<b>48 HOURS BEFORE YOU DIG, CALL UTILITY LOCATORS</b> <b>811</b> UTILITY NOTIFICATION CENTER OF COLORADO IT'S THE LAW	NO. REVISION	DATE	REVIEW:	PREPARED UNDER MY DIRECT SUPERVISION FOR AND ON BEHALF OF CLASSIC CONSULTING ENGINEERS AND SURVEYORS, LLC	MARC A. WHORTON, COLORADO P.E. #37155	DATE	<b>CLASSIC</b> CONSULTING ENGINEERS & SURVEYORS 619 N. Cascade Avenue, Suite 200 Colorado Springs, Colorado 80903 (719)785-0790 (719)785-0799(Fax)	FLYING HORSE NORTH FILING NO. 1 CONSTRUCTION DRAWINGS LIGHT POLE & MAIL KIOSK LOCATION PLAN (AS-BUILT PLAN)						
								DESIGNED BY	MAW	SCALE	DATE	04-14-20		
THE LOCATIONS OF EXISTING UNDERGROUND UTILITIES ARE SHOWN IN AN APPROXIMATE WAY ONLY. THE CONTRACTOR SHALL DETERMINE THE EXACT LOCATION OF ALL EXISTING UTILITIES BEFORE COMMENCING WORK. THE CONTRACTOR SHALL BE FULLY RESPONSIBLE FOR ANY AND ALL DAMAGES WHICH MIGHT BE CAUSED BY HIS FAILURE TO EXACTLY LOCATE AND PRESERVE ANY AND ALL UNDERGROUND UTILITIES.								DRAWN BY	MAW	(H) 1"= 200'	SHEET	1	OF	3

FLYING HORSE NORTH FILING NO. 1  
CONSTRUCTION DRAWINGS  
LIGHT POLE & MAIL KIOSK LOCATION PLAN  
(AS-BUILT PLAN)

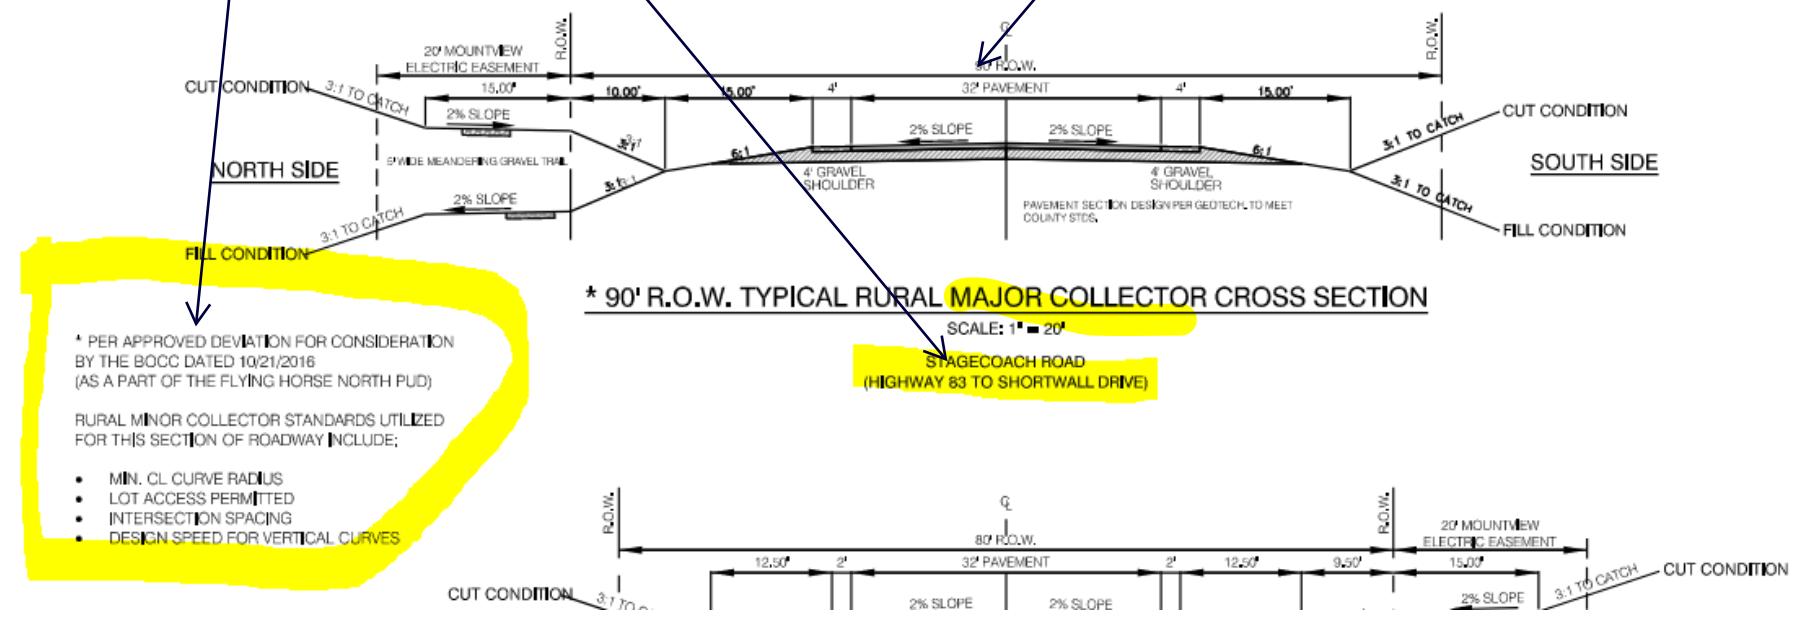
Revise classification to match approved plans. Major collector clear zone is 20'. The modification request did not include Clear Zone.

Relocate. Must be outside the clear zone per ECM 2.3.5 & 4.3.5.D.2

Relocate. Must be outside the clear zone per ECM 2.3.5 & 4.3.5.D.2

Relocate. Must be outside the clear zone per ECM 2.3.5 & 4.3.5.D.2

### STREET SECTIONS

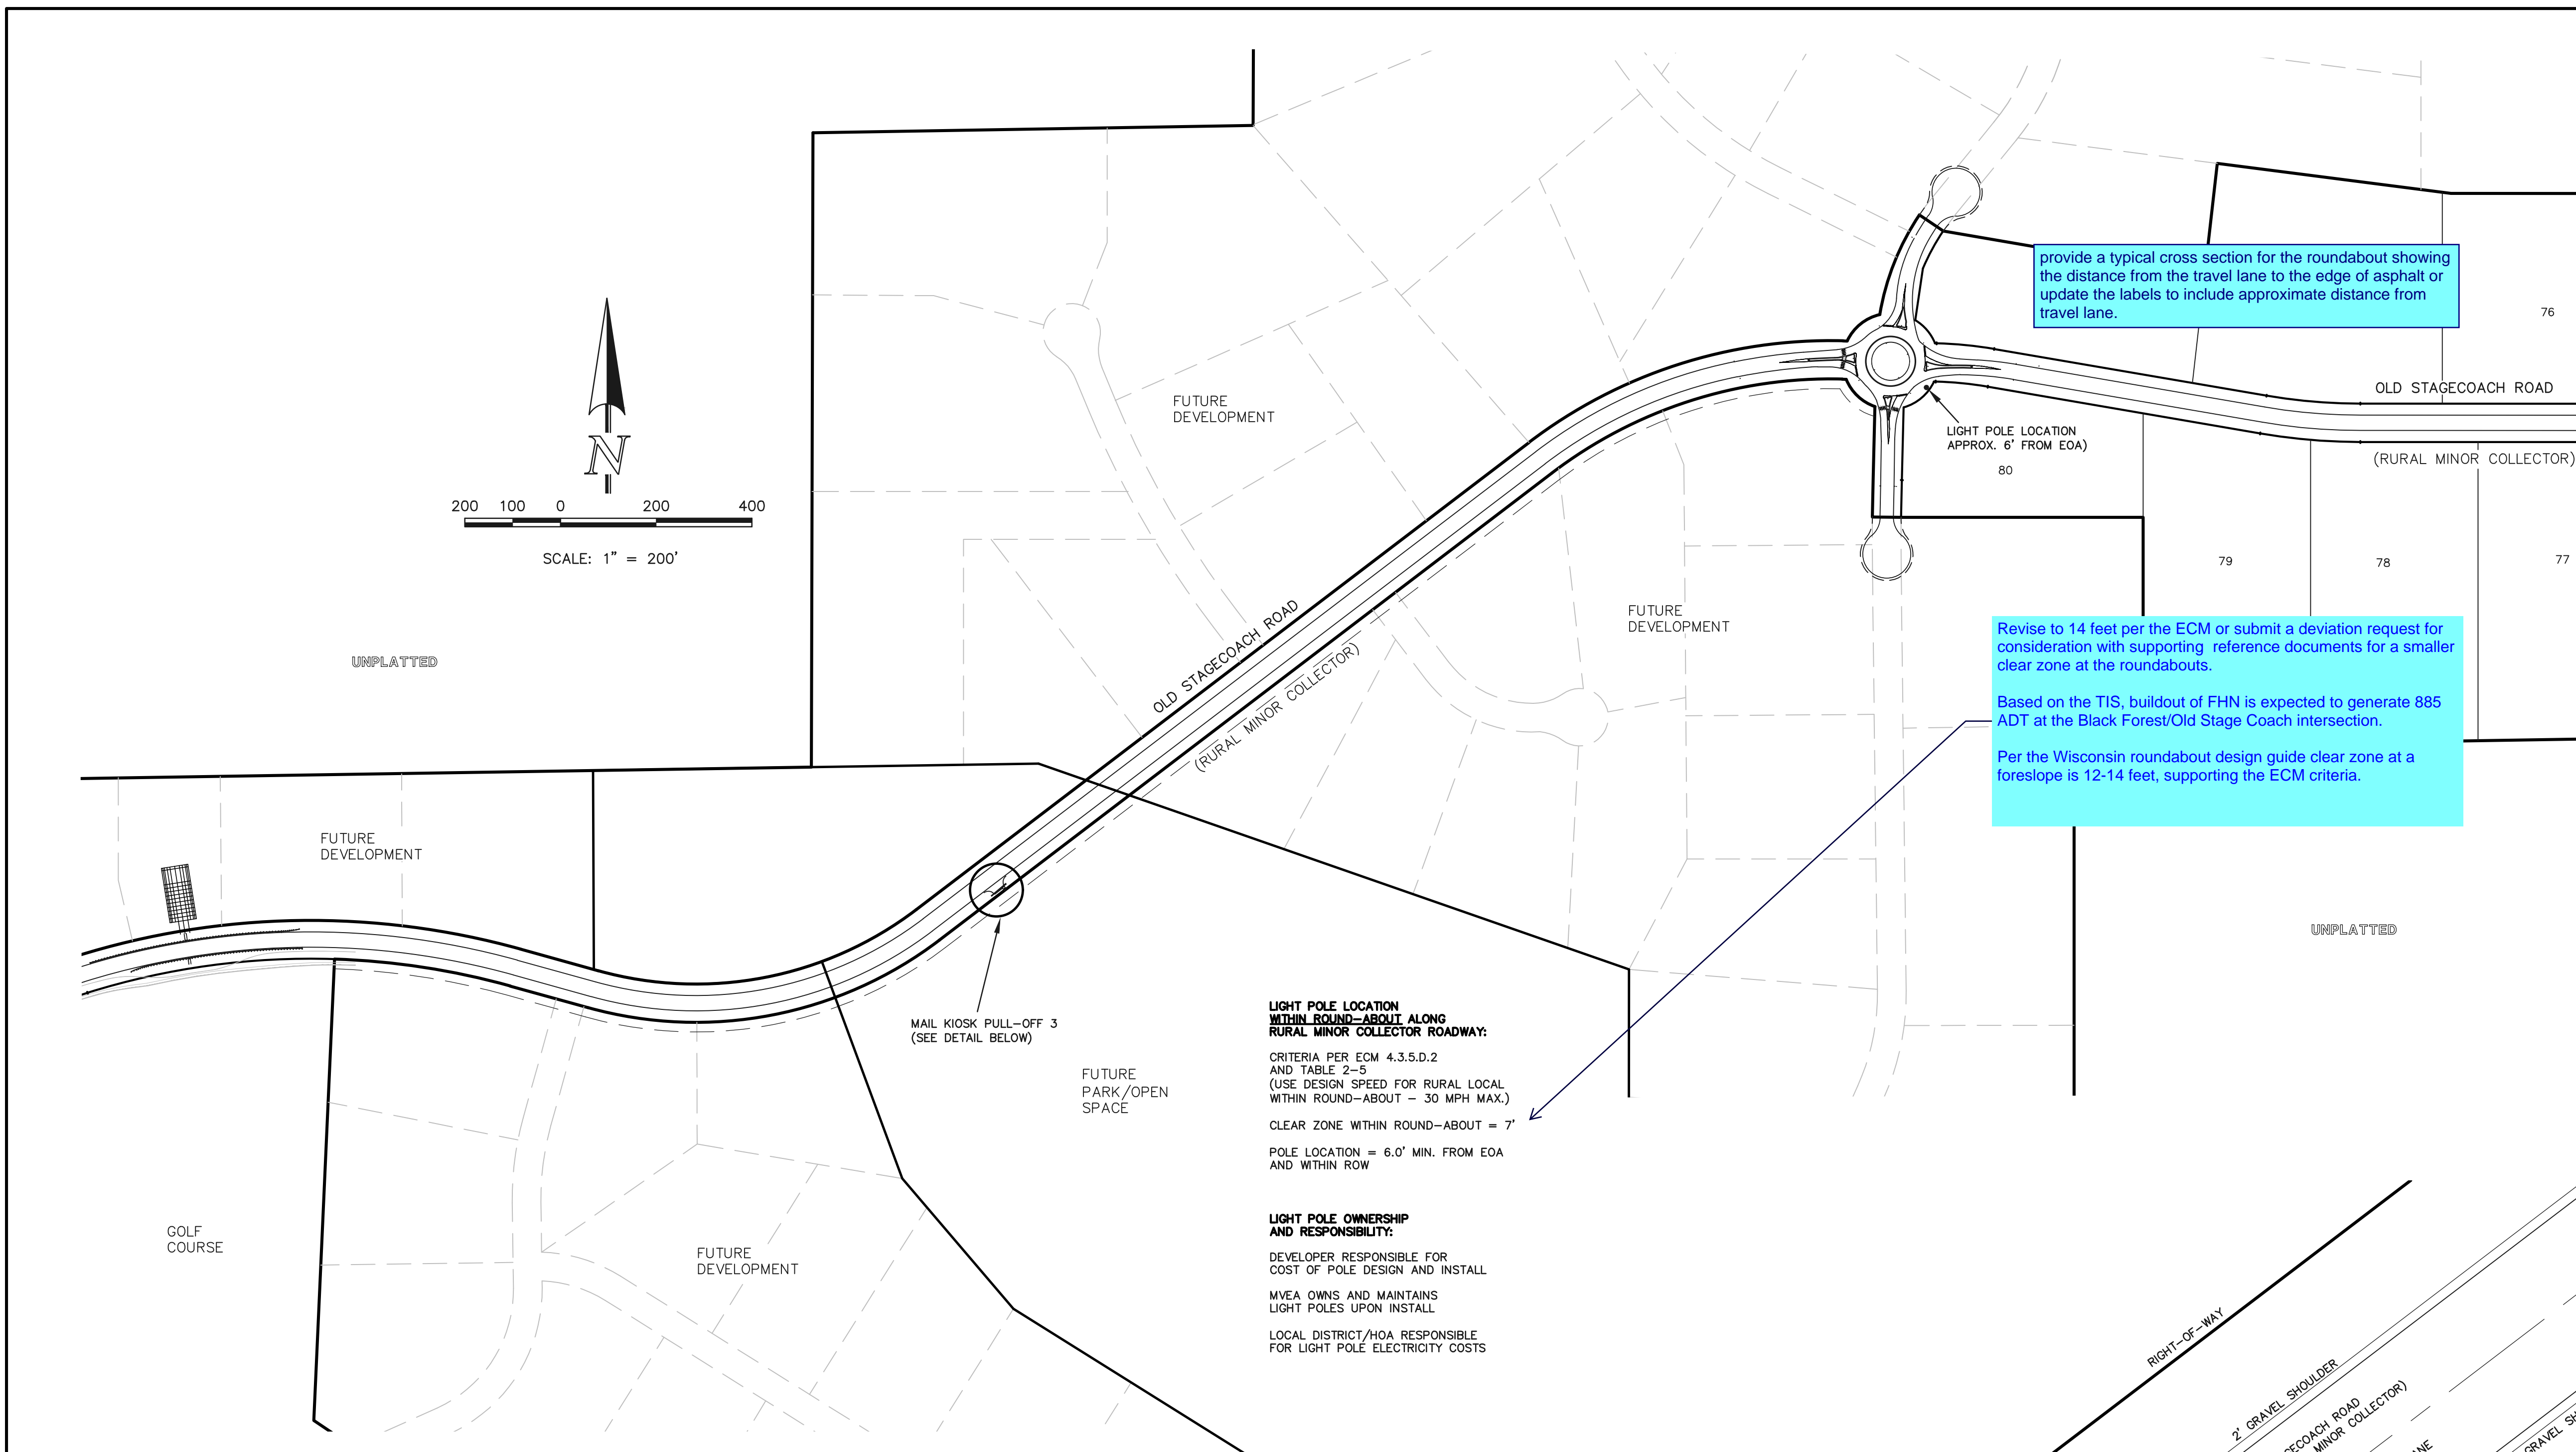
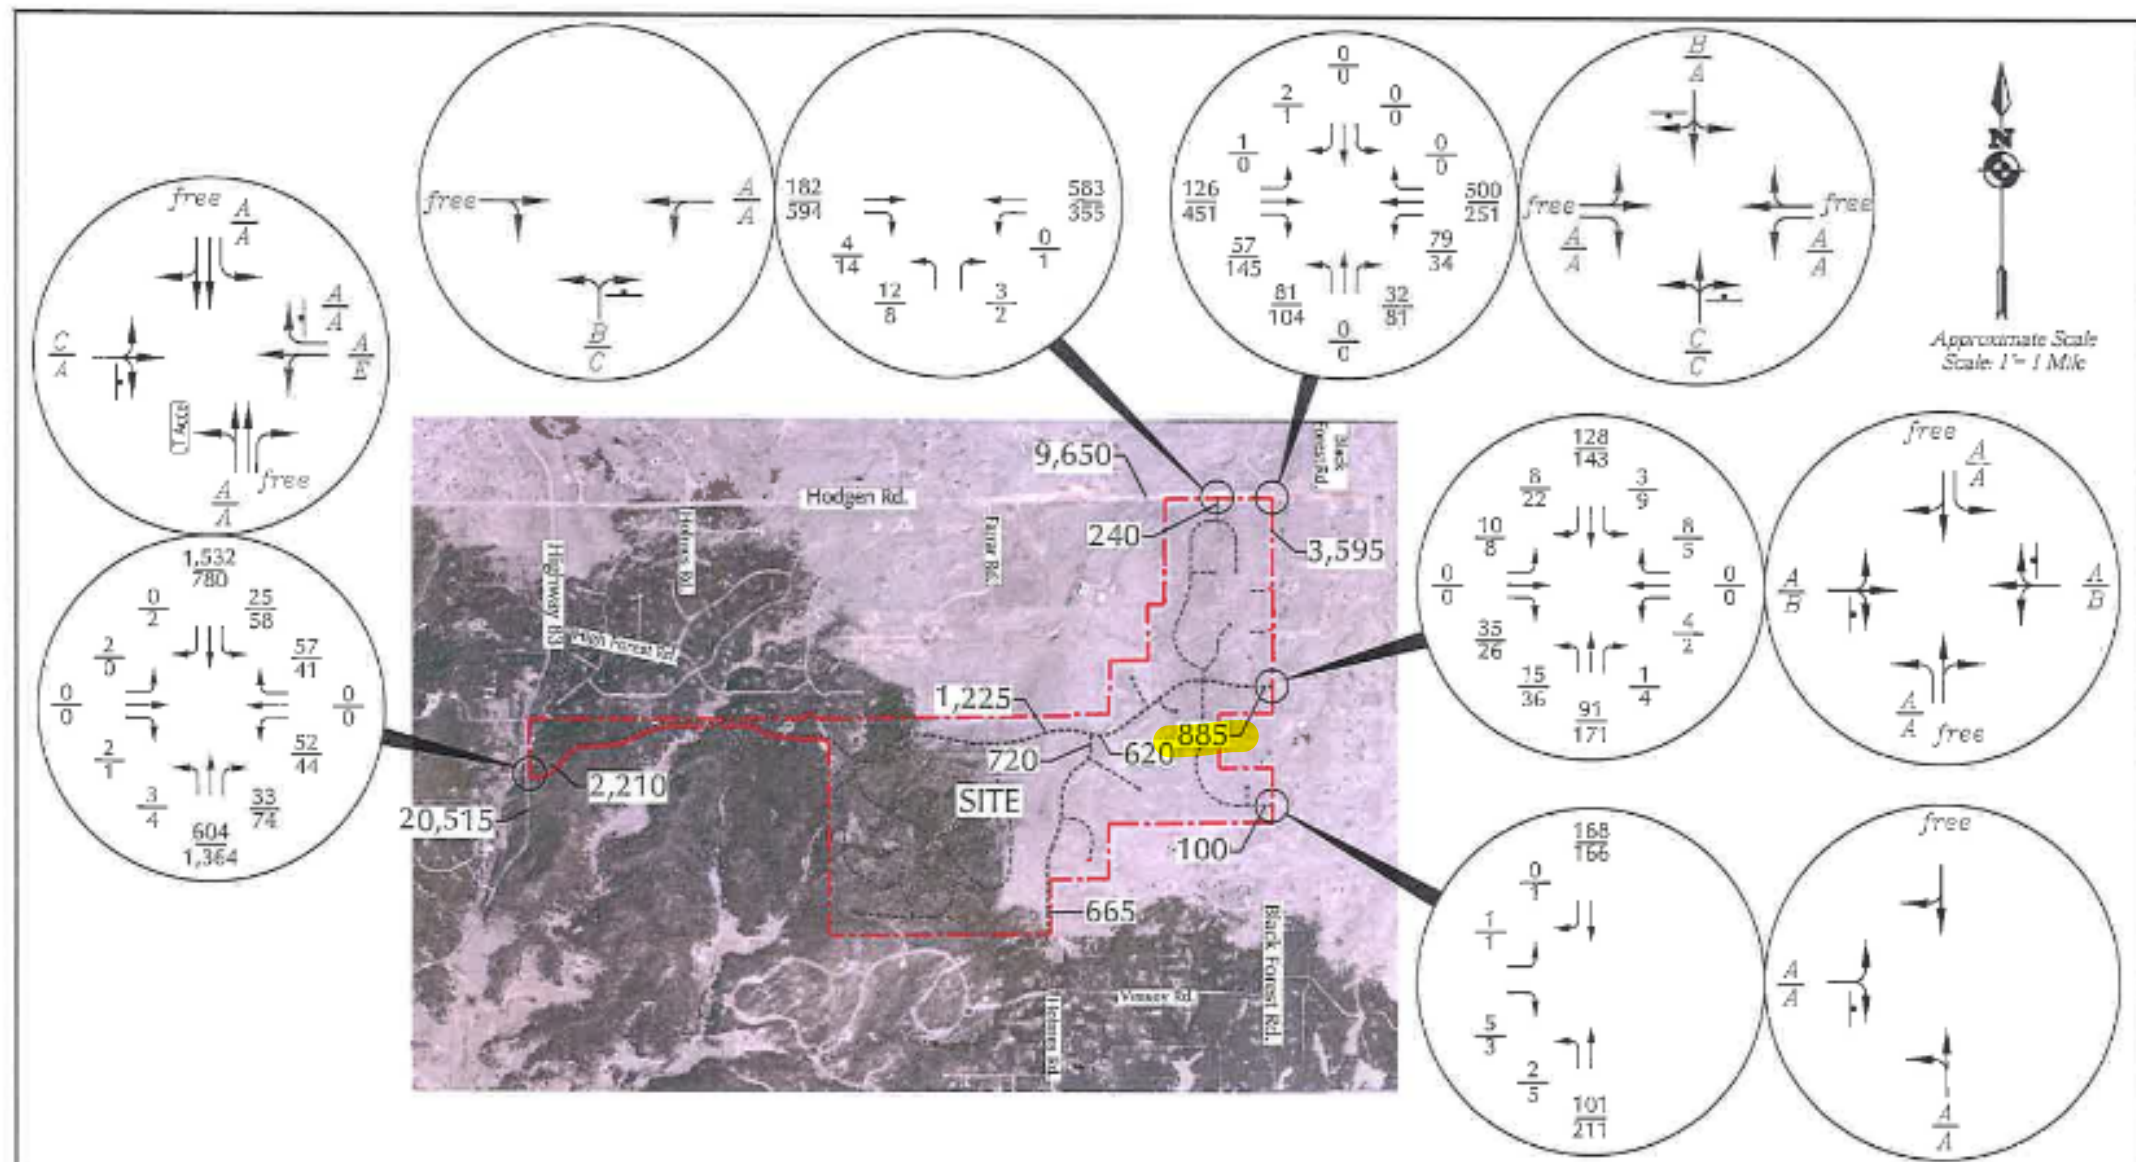
Add the typical street section. Modify to provide dimension label for the following:

1. travel lane (12' lane width)
2. from travel lane to EOP (4' paved shoulder)
3. Clear Zone (20' clear zone measured from edge of travel lane.)

Provide detailed grading.

Add light pole detail.

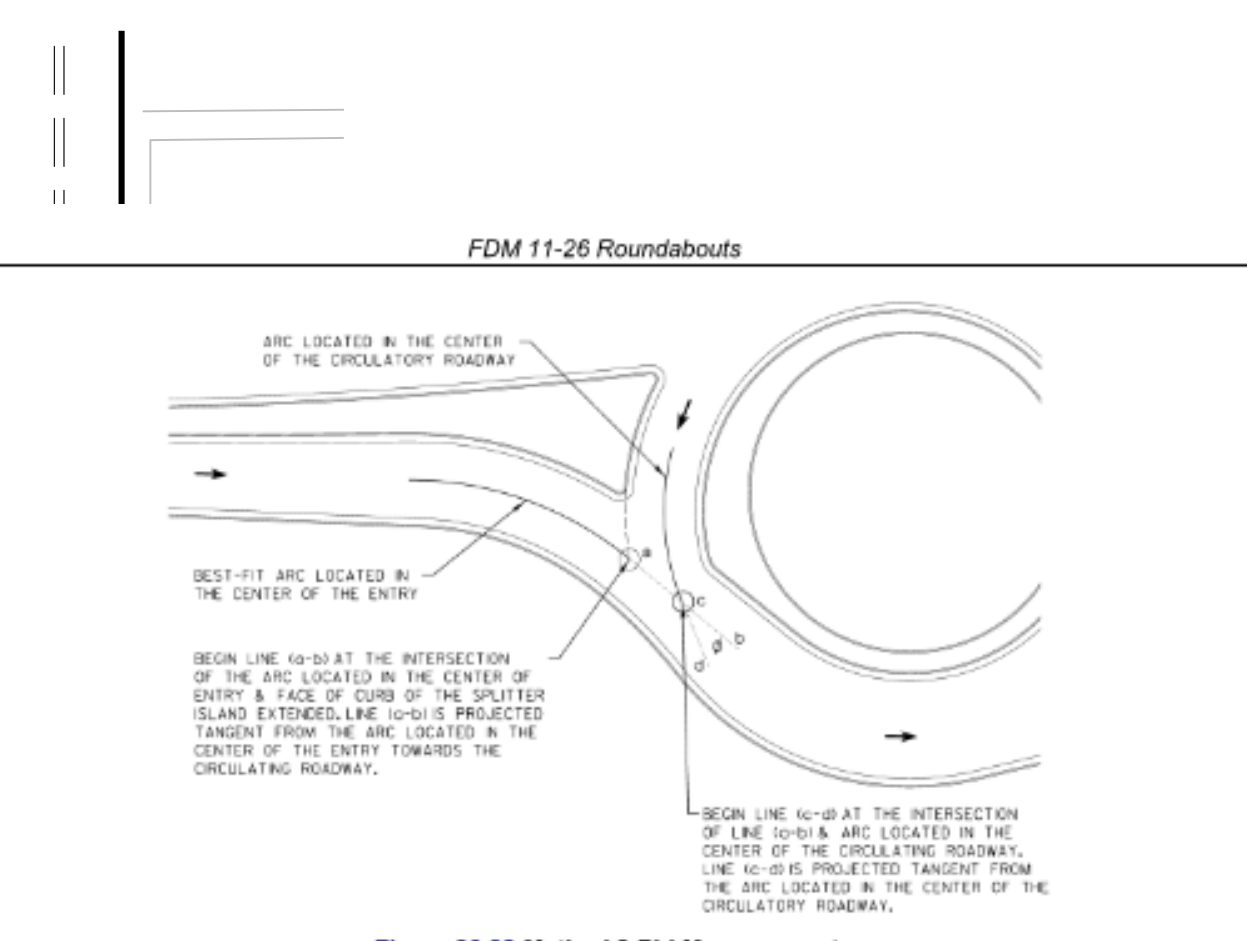
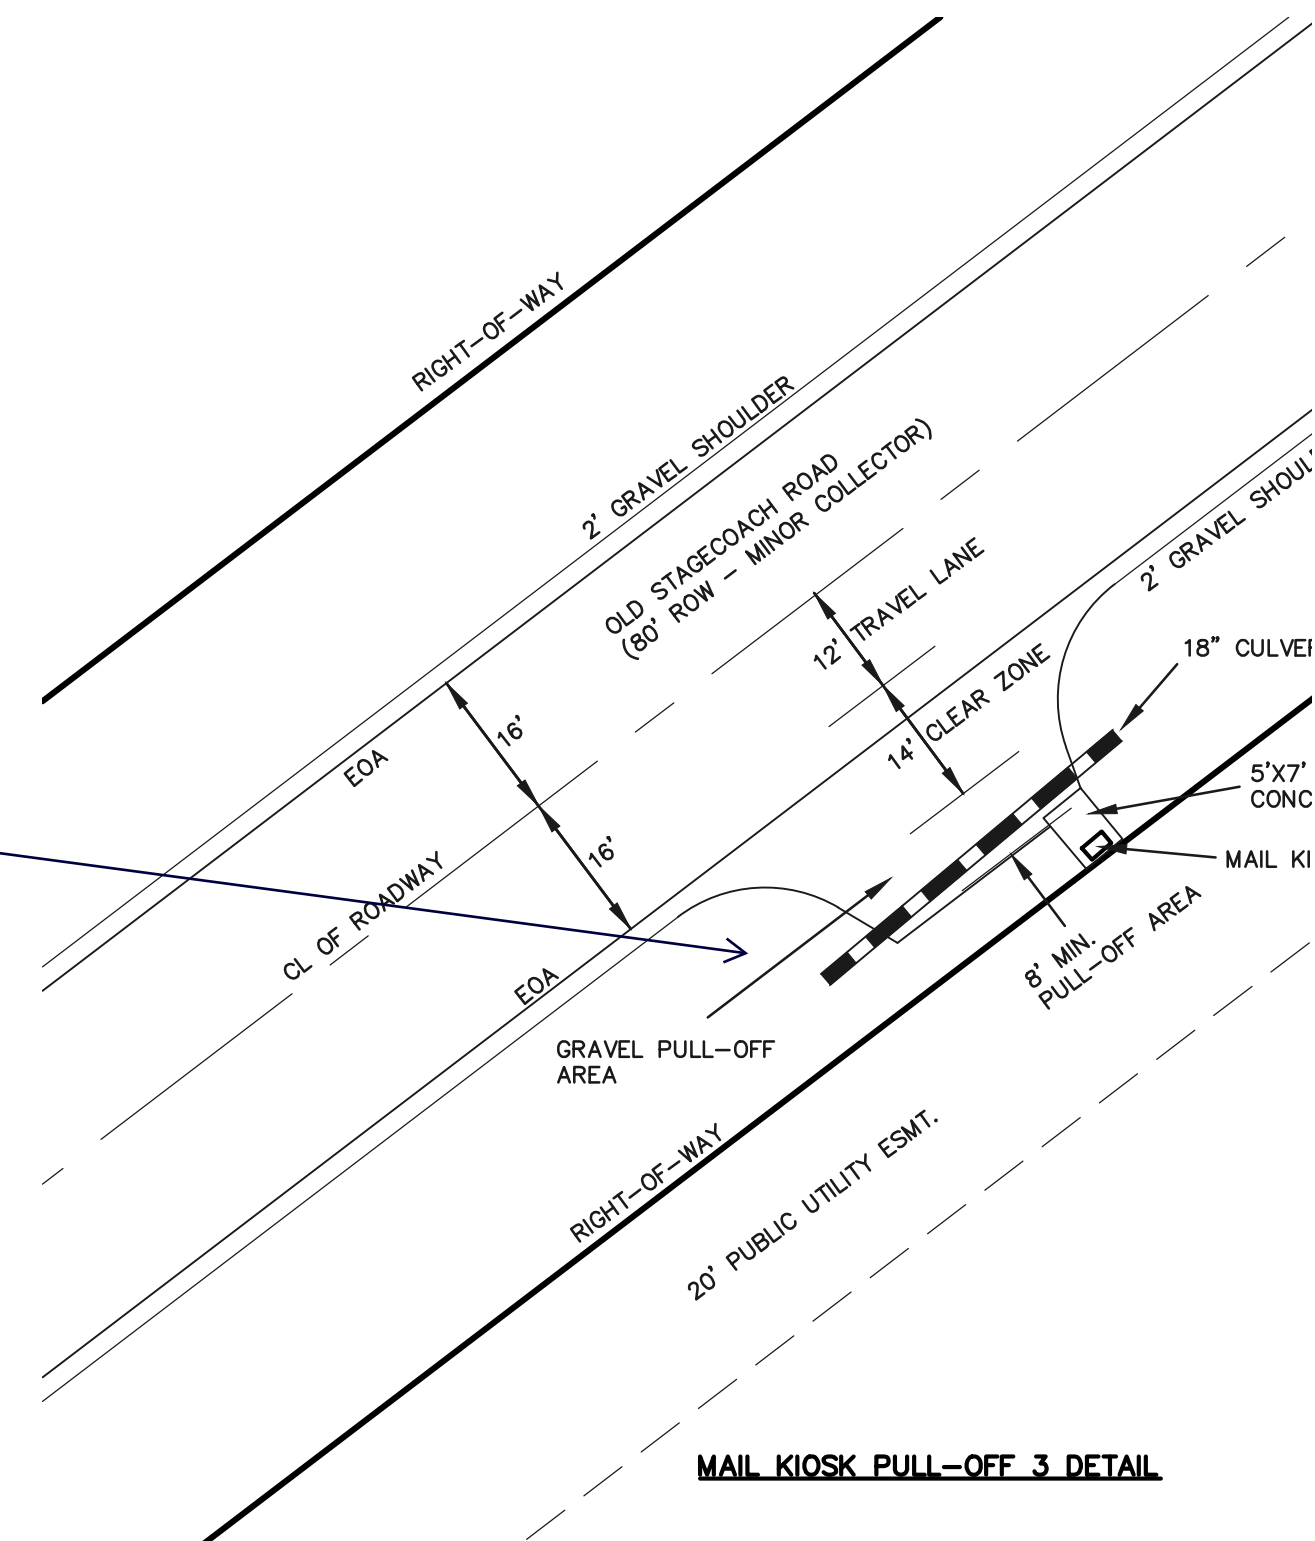
Provide detailed grading

FDM 11-15 Attachment 1.9 Modernization Clear Zone Distance Tables and Recovery Area Width Determination

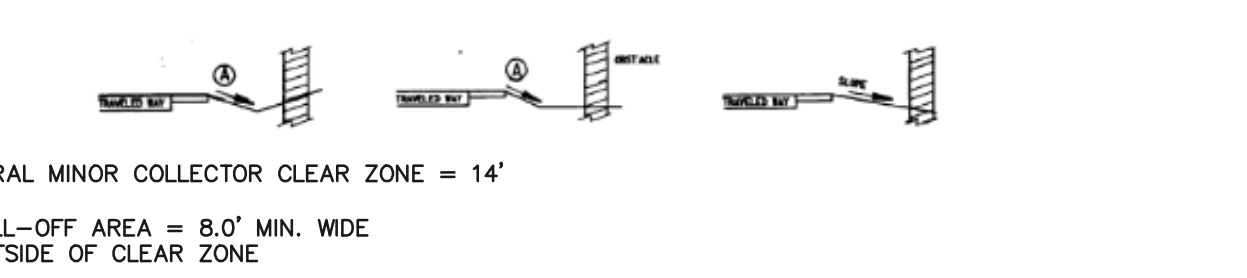
Move this sheet to the end of the set.
